Jimblebar Hub Significant Amendment: Response to Submissions

Table 1: Response to EPAS Comments, dated 11 April 2025

Table 2: Response to Public Submissions

JIMBLEBAR HUB SIGNIFICANT AMENDMENT EPWRMP ETHEL GORGE PRIMARY HABITAT ZONE GROUNDWATER LEVEL MONITORING

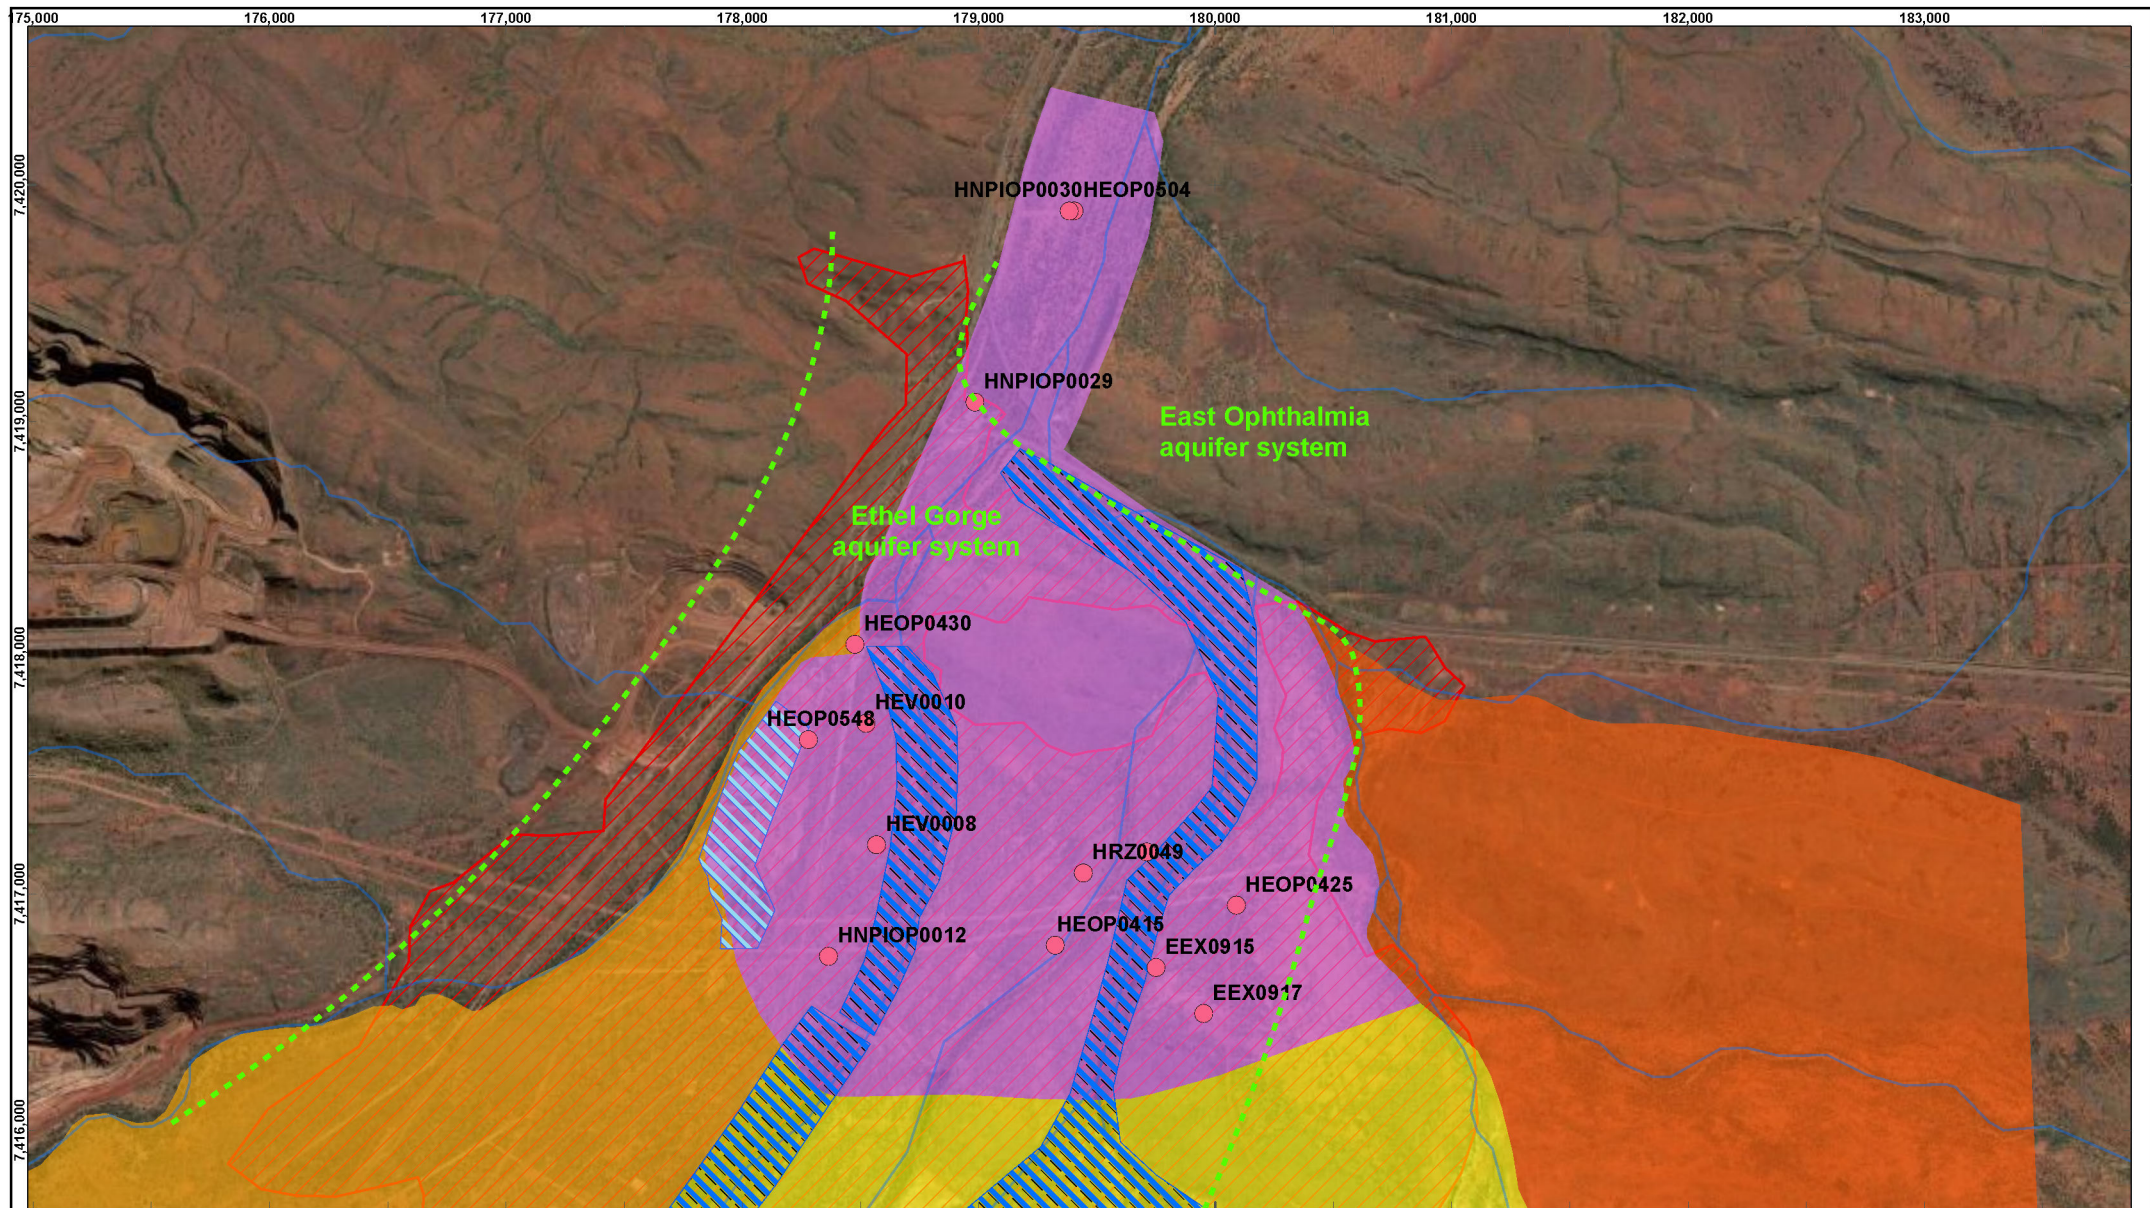
23.	DWER	Eastern Pilbara Water Resource Management Plan The ERD is supported by the East Pilbara Water Resource Management Plan (Rev8, December 2023) (EPWRMP) as Appendix 5. The intention of the EPWRMP is management of water-	BHP revised the groundwater level criteria in 2023 in Version 8.0 of the EPWRMP submitted with the Jimblebar Hub Mining Operations Significant Amendment referral. As discussed in Table 3 in the EPWRMP (Version 8.1), the revised criteria are based on monitoring of groundwater levels in the Ethel Gorge Primary Habitat Monitoring Zone, which shows that groundwater levels have historically usually been above 494 mRL.

Comment Number	Submitter	Submission and/or issue	Response to comment												
		related activities that have the potential to impact the Ethel Gorge TEC from BHP proposals. The ERD identifies that additional drawdown as part of the significant amendment is not predicted to migrate west of the Wheelarra Fault and will not reach the Ethel Gorge TEC. However the surplus water management operations across the Newman area and Jimblebar Hub are based on the use of Ophthalmia Dam. The EPWRMP (Rev8) has revised groundwater level criteria that relate to groundwater decline based on observed groundwater levels, with the early response indicator set at 494 mRL (Table 6), and trigger criteria and threshold criteria of 494 and 490 mRL respectively. Time series of Ethel Gorge monitoring bores provided in Figure 12 of the Western Ridge and OB29/30/35 Detailed Hydrogeological Assessment (BHP 2022, refer figure below) indicate that groundwater levels in Ethel Gorge aquifer have only been recorded below 494 mRL following sustained regional drawdown associated with Ophthalmia Borefield operation, and prior to Ophthalmia Dam. Groundwater levels in the Ethel Gorge aquifer were reported above 500 mRL prior to abstraction from the bore field or mine dewatering. Action: Update the EPWRMP to include time series Ethel Gorge aquifer groundwater levels and rationale to support the revised groundwater level criteria.	Figure 2-1 attached with this response (following Table 2) shows the location of monitoring bores adjacent and in the Ethel Gorge Primary Habitat Monitoring Zone with long term records. Figure 2-2 shows the time series of groundwater levels at the monitoring bores shown in Figure 2-1, which BHP used to revise the EPWRMP groundwater criteria (early warning criteria of 494 mAHD, trigger of 492 mAHD, and threshold of 490 mAHD). and which BHP uses to assess groundwater levels against criteria in the EPWRMP. The revised groundwater level criteria represent an appropriate range which allows for the variation in anthropogenic activities in the Ethel Gorge area (including groundwater abstraction for Newman water supply from the Ophthalmia Borefield, commissioning of the Ophthalmia Dam MAR System, mine dewatering and surplus discharge to the Ophthalmia Dam system). As shown in Figures 2-1 and 2-2, while groundwater level measurements in some bores during the period of record have been greater than 497 mRL, groundwater levels in most bores have been lower than 494 m during the period of record. The following table provides a comparison of the endorsed (EPWRMP v6.0) and revised (EPWRMP v8.0) groundwater level criteria. The revised groundwater level criteria are more appropriate than the endorsed criteria because they provide easier to interpret, defined water level elevations (rather than the current criteria of changes in groundwater level against an undefined reference level), while remaining within the range of the previous criteria. EPWRMP endorsed and revised groundwater level criteria

* based on a typical groundwater elevation of 500 mRL since 2005 The revised groundwater level criteria are also outcomes-based and represent the lower range of groundwater levels to maintain the habitat of, and minimise impacts to, the Ethel Gorge Aquifer TEC. As discussed in Table 3 in the EPWRMP (v8.1): - BHP has undertaken annual stygofauna monitoring in the Ethel Gorge TEC since 2009 - the area has experienced substantial changes in groundwater levels, due to groundwater abstraction, dewatering activities, recharge through Ophthalmia Dam, and climatic variation. However, to date, no measurable impacts on the stygofauna community have been observed - thirty-nine 'core endemic' species have been recognised from the Ethel Gorge area from monitoring programs conducted annually since 2009. Species accumulation modelling estimates that between 75.5 to 94.6 percent of the assemblage predicted to exist within the Ethel Gorge area has been recorded - the findings of the [2022/2023] Program along with previous surveys indicate that current groundwater management practices have been appropriate to prevent potential impacts to the Ethel Gorge stygofauna TEC from BHP operations. It is also considered that adequate saturation of the core habitat has been maintained, enabling the persistence of stygofauna. The draft findings of the 2023/2024 monitoring program (Stantec 2025 in prep) are consistent with the finding of previous monitoring rounds. Therefore, based on the information above, BHP considers that the revised groundwater level criteria are appropriate as a surrogate measure to maintain the habitat of the Ethel Gorge TEC, and are more appropriate than the endorsed criteria. BHP will add a summary of the justification provided in this response, in the next version of the EPWRMP submitted to DWER (as at May 2025 the EPA is also reviewing the EPWRMP V8.1 as part of the assessment of the Orebody 29/30/35 Significant Amendment Proposal).

Figure 2-3: Comparison of settlement in De Grey and Swan in-pit TSFs

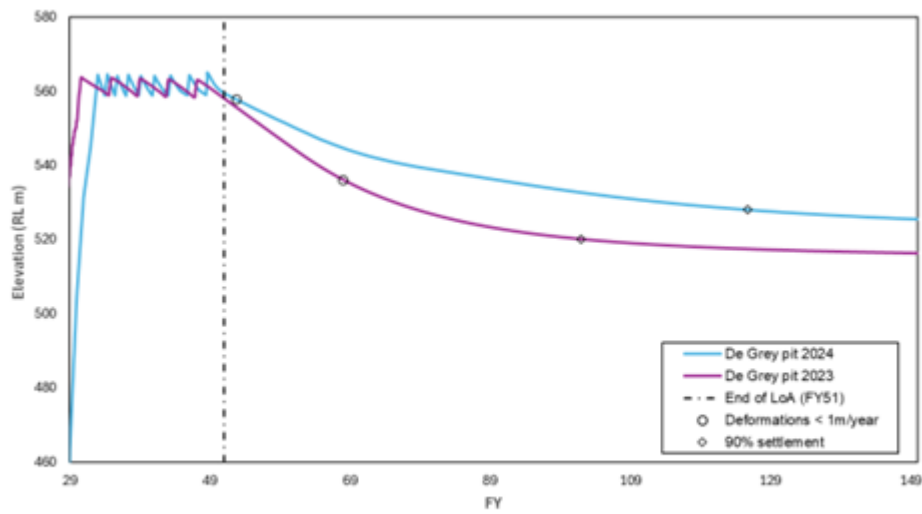
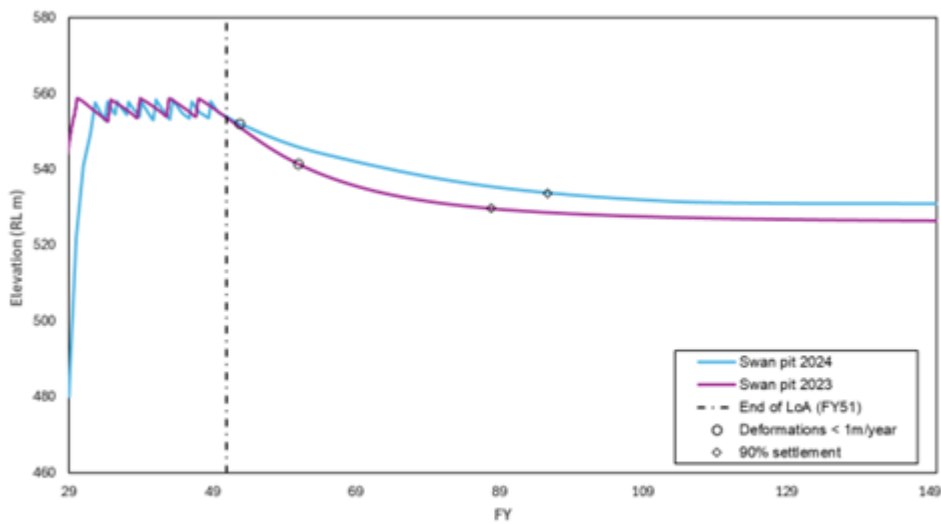
30.	DEMIRS	The Mine Closure Plan provided has been revised to include the proposed additional activities. DEMIRS is concerned about the length of time estimated for consolidation of the tailings in the in-pit tailings storage facilities (IPTSFs), which is noted to be 10-20 years (Appendix 7, Mine Closure Plan – Executive Summary Table 1).	As part of ongoing pre-planning for the disposal of tailings to the in-pit TSFs, further consolidation modelling and cover implementation timing was undertaken in 2024 (Attachment 2 Design Report, Appendix F Consolidation Modelling) as it was agreed that the time between final tailings deposition and emplacement of an engineered cover should be minimised. Figure 2-3 of this response (following Table 2) illustrates the latest tailings consolidation modelling for De Grey and Swan pits. The change in settlement rates is due to an optimisation in the spigot locations for tailings discharge. It is now forecast that deformation rates of less than 1 m per year will occur within 2 years of final tailings deposition. Emplacement of the final engineered surface could

Comment Number	Submitter	Submission and/or issue	Response to comment
		Action: Further assessment of options to improve the rate of settlement and consolidation of tailings are needed to inform operational management of tailings to ensure timely rehabilitation of the IPTSF.	occur at this time, and likely earlier for areas of the pit void where the thickness of tailings is less than 10 m. The first layer of the cover will be a “pioneer” layer designed to create a safe construction base for cover emplacement. Options to further enhance dewatering and settlement including wick drains have also been identified. During operations, settlement rates will be confirmed through lab testing of the tailings properties. This will provide a dataset that will allow detailed 3D consolidation modelling. The above information will be updated into the next version of the Jimblebar Hub MCP (planned for 2026).

31.	DEMIRS	The consolidation of the top surface of the IPTSFs aspect is missing in the IPTSF Domain Key outcomes, closure risks and controls listed in Executive Summary Table 1 of the Jimblebar 2023 MCP. Action: This omission should be modified so that the outcomes/risks/controls in the MCP align with the Key Knowledge Gap section that states: “Opportunities for enhancing tailings settlement and drainage to reduce the timeframe over which closure works can be safely operated (currently tailings will take 10 to 20 years to consolidate enough to allow earthmoving machinery to place the cover).”	Closure risks associated with consolidation of the top surface of in-pit TSFs will be reassessed based on updated information from studies undertaken in 2024 (see response to Comment 30 above) where consolidation profile is now predicted to result in more favourable conditions to reduce timeframes for closure execution.

JIMBLEBAR HUB IRON ORE MINING OPERATIONS Terrestrial fauna mitigation

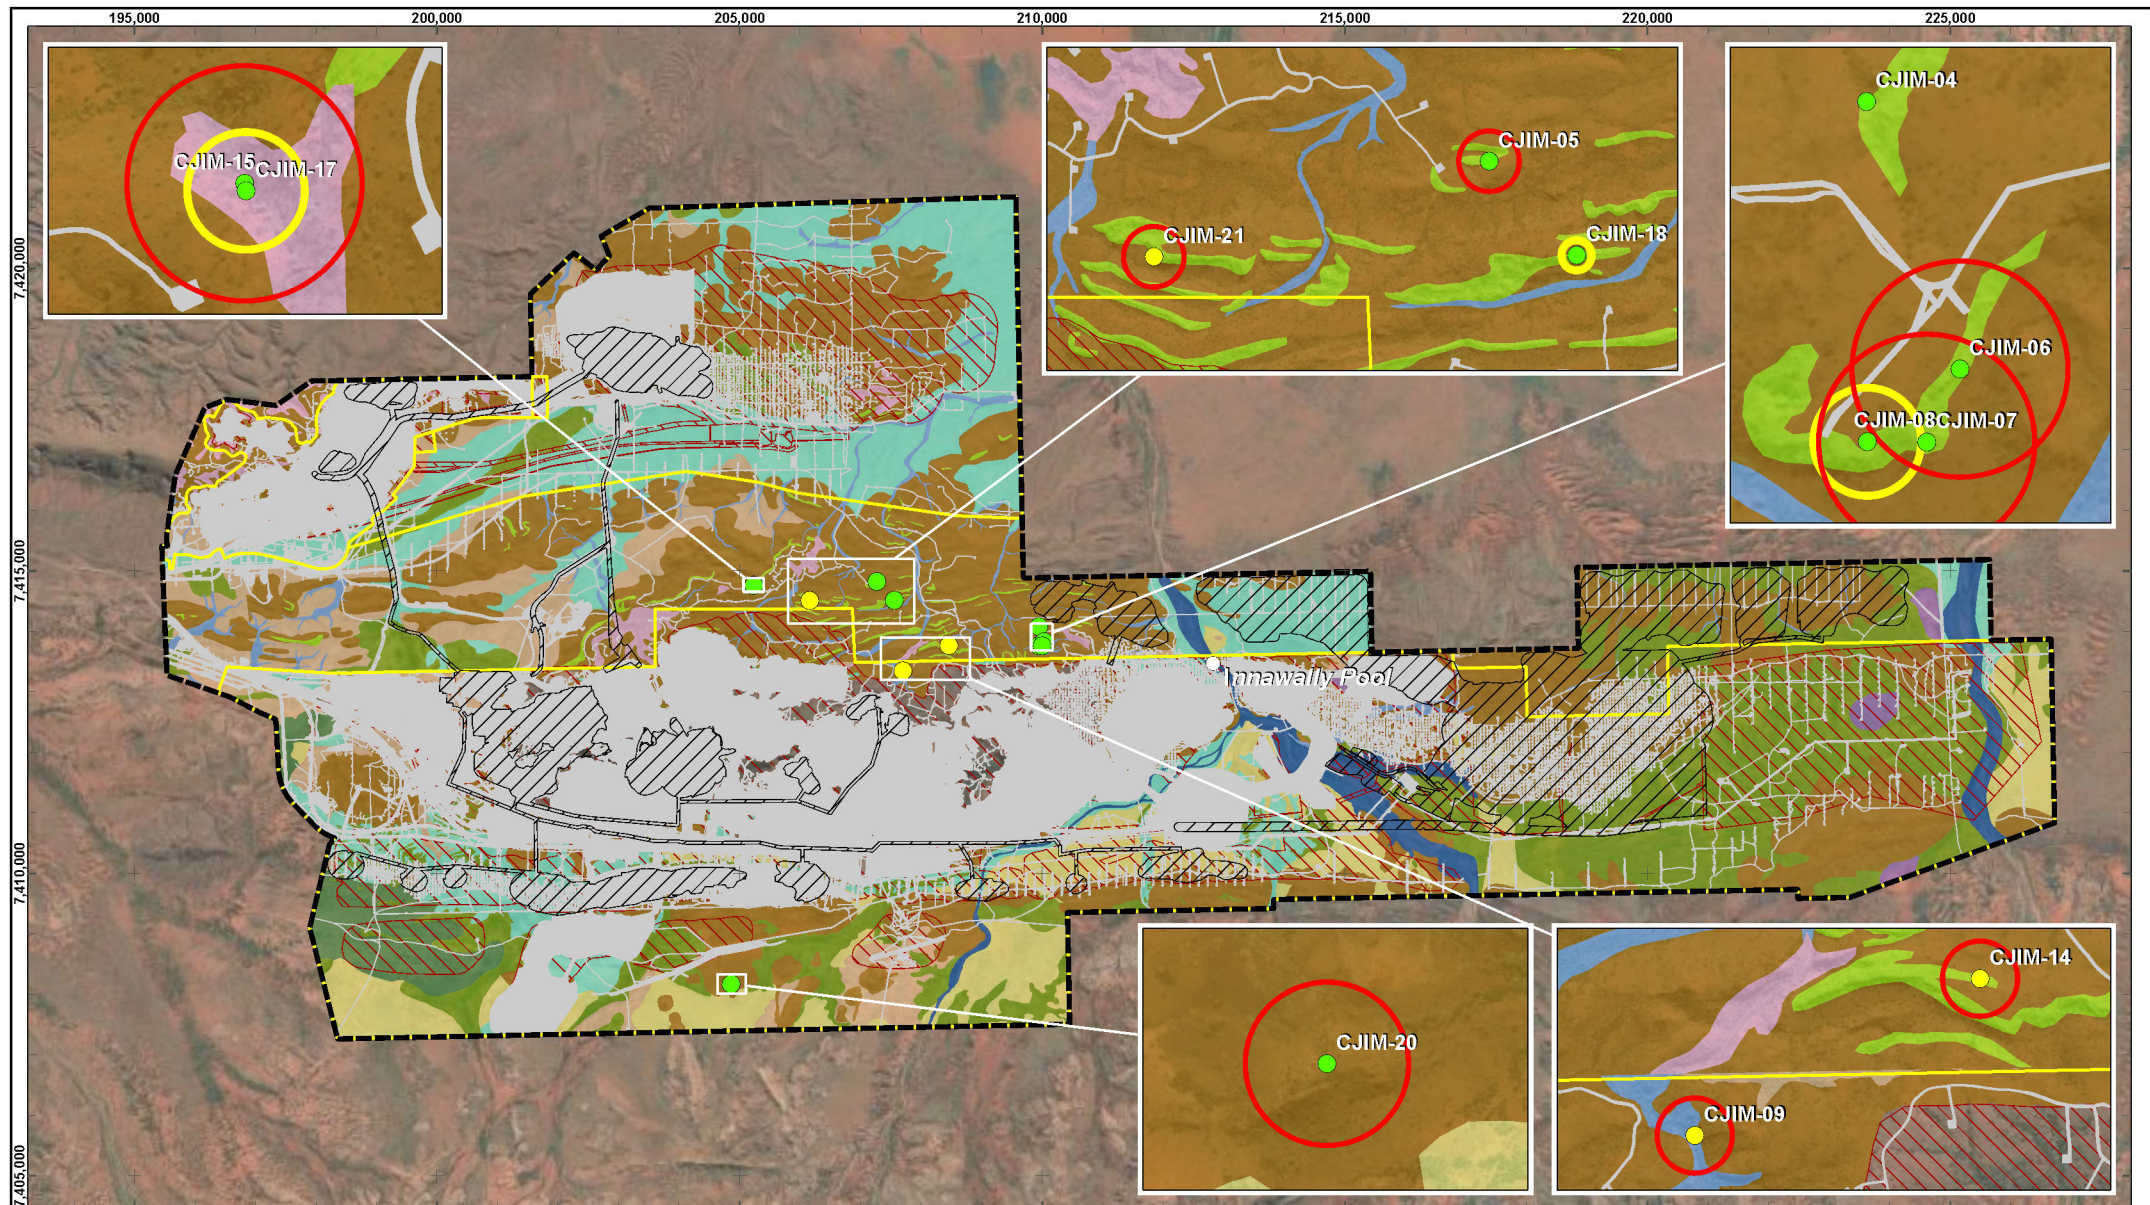
19.	DBCA	DBCA notes that the ERD proposes buffers around ghost bat caves to ensure the caves are retained. From the available information, ghost bat caves within the DE appear to provide the only known link between two important maternity roosts in the local area. Given none of the caves proposed to be retained within the DE are within 250 metres of the indicative footprint, cave buffers should be expanded, without impacting on proposed activities, which would give further certainty that the local ghost bat population is not adversely impacted by the proposal. Cave buffers should be developed on a case-by-case basis, informed by geotechnical assessment of caves and predicted noise and in-ground vibration impacts.	The Jimblebar Terrestrial Fauna EMP already includes a commitment to inspect Category 4 roosts CJIM-04, 08, 17 and 18. Note that as identified in Table 9-4 of the ERD, these caves have no evidence of use. BHP has reviewed the Ghost Bat cave buffers and for the following caves, has increased the buffers from 50m to 100m: • CJIM-05 • CJIM-06 • CJIM-07 • CJIM-15 • CJIM-20. BHP has also applied a 50m buffer to: • CJIM-08

Comment Number	Submitter	Submission and/or issue	Response to comment
		Buffers should also consider the management and mitigation of indirect impacts, including artificial light, and other habitat features important to the local persistence of ghost bat (i.e. water sources). Action: • Include management actions in the ERD and Terrestrial Fauna Management Plan to inspect category 4 ghost bat roosts prior to disturbance and displacement of ghost bats, should they be present. • To give further certainty that the local ghost bat population is not adversely impacted by the proposal, it is recommended that cave buffers are expanded without impacting on the proposal. • Management actions in the Terrestrial Fauna Management Plan to inform cave buffers are required should the indicative footprint change. Buffers should be informed by geotechnical assessment of caves and predicted noise and in-ground vibration impacts. • The removal of threatened fauna from their habitat through displacement and/or exclusion requires Ministerial authorisation under section 40 of the Biodiversity Conservation Act 2016 (BC Act). Consultation with DBCA in relation to an authorisation is required, and further information, in addition to what has been provided in the ERD and the Terrestrial Fauna Management Plan, will be required	• CJIM-17 • CJIM-18. BHP has updated the TFEMP (Version 1.2) to include the revised buffers and provides updated spatial data to this effect. This is provided as Attachment 6. BHP notes the requirement for approval under Section 40 of the BC Act.

Comment number	EPA Services Comments	Proponent Response
		All of these caves are labelled on Figure 9-4 of the ERD. Cave categories are provided in Attachment 1, Table 1. A map showing updated buffers is provided in Attachment 1, Figure 1.
